Comment Set F0003
USDA Forest Service – Cleveland National Forest

RE: Forest Service Comments on the Recirculated Draft Environmental Impact Report / Supplemental Draft Environmental Impact Statement (RDEIR/SDEIS) for the Sunrise Powerlink Project (SCH No. 2006091071, DOI Control No. DES-07-58)

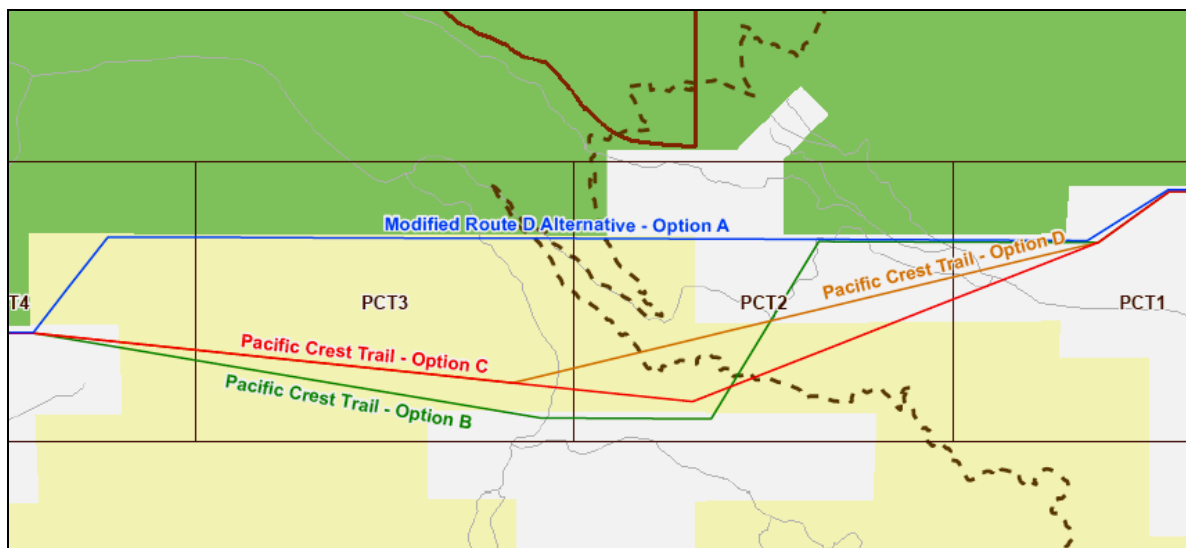
F0003-7

Although this section of the PCT is on public lands managed by the BLM, the PCT is maintained by the Forest Service under a right-of-way reservation from the BLM. I am enclosing a copy of the reservation for the record. Under condition three:

The Final EIR/EIS should evaluate the impact to the PCT in the context of the right-of-way reservation, and detail how the construction and operation of the project would affect the use of the PCT.

Regarding the Pacific Crest Trail (PCT) reroute, the comment identifies that PCT is on public lands managed by BLM, but that it is maintained by the Forest Service under a right-of-way reservation. Under the reservation, BLM retains the right to occupy and use the ROW and to grant ROWs to others, provided that the occupancy and use will not unreasonably interfere with the rights granted to the Forest Service for the PCT. The commenter requests that the Final EIR/EIS evaluate the impact to the PCT in the context of the ROW reservation, detailing how the construction and operation of the project would affect use of the PCT. The affects on the PCT, including construction impacts, are analyzed in Section E.4.5 (Wilderness and Recreation).

The Modified Route D Alternative (PCT Option A) would cross the PCT in three locations within about a mile just south of the Hauser Wilderness, due to the circuitous nature of the trail in the area the alternative would traverse (see map below). The PCT Reroute (PCT Option B), described and analyzed in Section 3.3.6 of the RDEIR/SDEIS, would shift the transmission line south, where it would cross the PCT only once. As described in Response to Comment F0003-6, a modification of the PCT Reroute (PCT Option B), called the PCT Option C/D, is analyzed in Section E.4 of the Final EIR/EIS. The PCT Reroute (PCT Option B) considered in the RDEIR/SDEIS has been eliminated from consideration and deleted in the RDEIR/SDEIS.

In addition, a new mitigation measure has been added to the impact analysis for Recreation and Wilderness in Section E.4.5.2, to require consideration of a reroute of the PCT, in the event that the Modified Route D Alternative is selected. The reroute would eliminate two of the three PCT crossings, to reduce the permanent change of recreational character of this area that would result from the installation of a 500 kV transmission line in this sensitive spot between two wilderness areas. Mitigation Measure WR-2b is as follows:

WR-2b Evaluate and Implement PCT Route Revision. SDG&E shall consult and coordinate with the U.S. Forest Service, BLM, and the Pacific Crest Trail Association to develop route options for revising the PCT so it would cross the Modified Route D Alternative only once, rather than three times. SDG&E shall prepare and submit a report to the BLM and U.S. Forest Service prior to energizing the new transmission line. The report shall identify feasible PCT relocation options, and, under the direction of the federal agencies, shall evaluate whether its construction and restoration of the old trail segment would create overall greater impacts than those created by three crossings of the PCT that would occur with the Modified Route D Alternative. If directed by the BLM, SDG&E shall be responsible for constructing the new trail segment and restoring the old trail segment in manner acceptable to the BLM and U.S. Forest Service. Trail construction and restoration shall be completed within one year of energizing the transmission line.
